**NOTICE OF TYPE II DECISION
SUBDIVISION (SUB) 2007-00002
WALNUT CROSSING SUBDIVISION**

FILE NAME: WALNUT CROSSING SUBDIVISION
CASE NOS.: **Subdivision (SUB)** **SUB2007-00002**
Adjustment (VAR) **VAR2007-00006**

REQUEST: The applicant requests Subdivision approval to divide a 2.33 acre parcel into nine (9) single-family lots, keeping an existing residence on one of the proposed lots, and an access spacing Adjustment to the 200-foot spacing standard for collector streets.

PRELIMINARY SITE PLAN

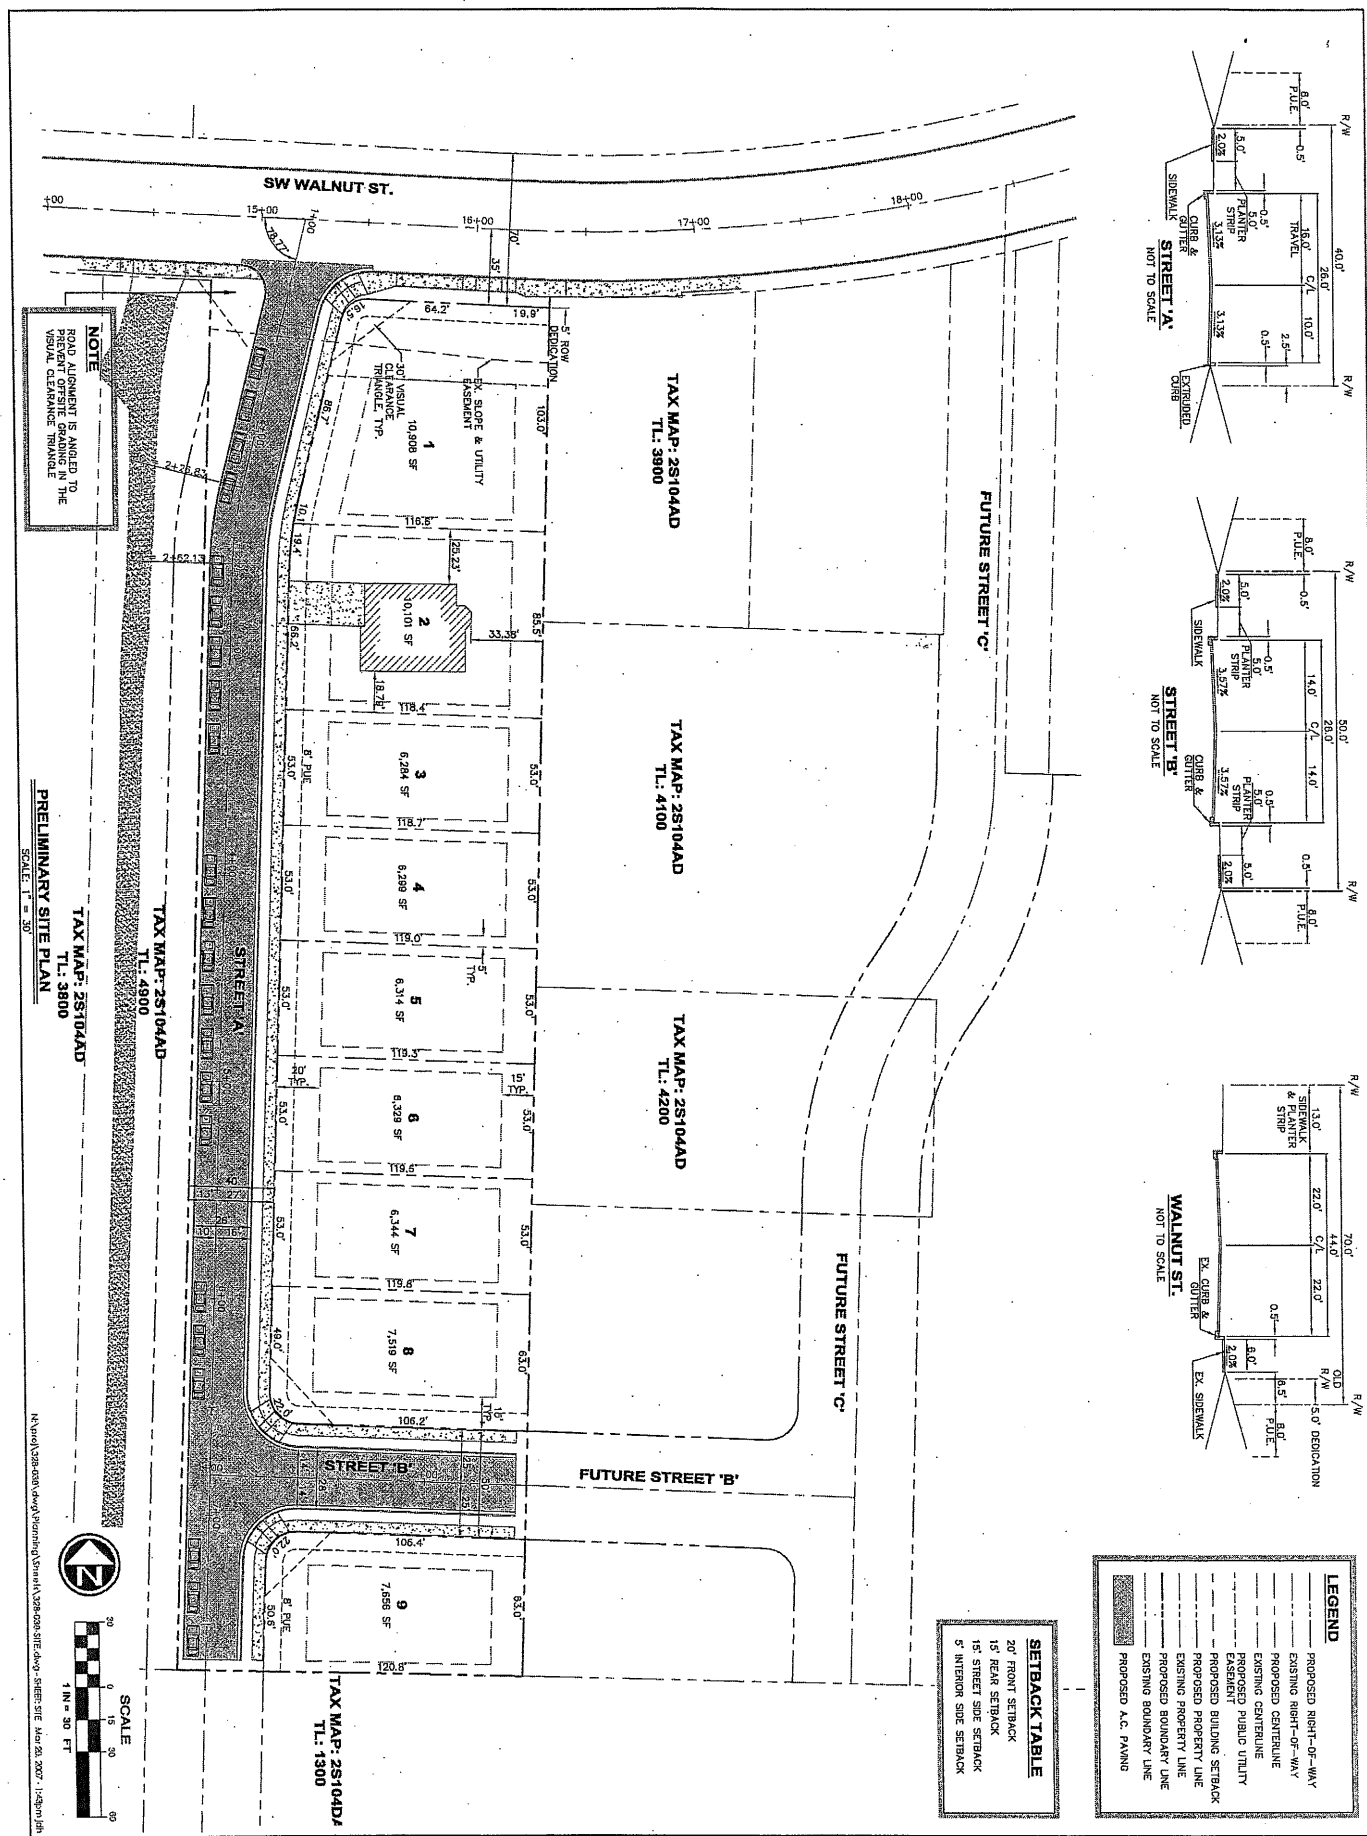
At this time, there are no approved plats or maps for proposed development on adjoining properties. However, future streets plans are shown on the Preliminary Site plan (Sheet 3) and in the aerial photo (Sheet 7), consistent with this standard.

The applicant has shown vision clearance areas on the Preliminary Site plan for the intersections of proposed Street ‘A’ with SW Walnut Street and the proposed Street ‘B’. At the time of building permit review, site plans for each lot will show driveways that intersect with Street ‘A’ where visual clearance areas shall contain no vehicle, hedge, planting, fence, wall structure, signs, or temporary or permanent obstruction exceeding three feet in height.

The proposed subdivision includes new streets, Streets 'A' and 'B'. The Preliminary Sit Plan (Sheet 3) shows a future streets plan connecting the proposed street back to SW Walnut with a block length of approximately 1,600 lineal feet, consistent with this standard.

10. The construction plans shall show the driveway locations for Lots 1 & 2 located as far south from Walnut Street as possible.
11. The applicant shall submit construction plans to the Engineering Department as a part of the Public Facility Improvement permit, indicating that they will construct the following frontage improvements along SW Walnut Street as a part of this project:

- 28. Prior to issuance of building permits for proposed Lots 1 and 2, the applicant shall submit a site plan locating the driveways as far south as possible to avoid conflict with the influence area with SW Walnut Street.
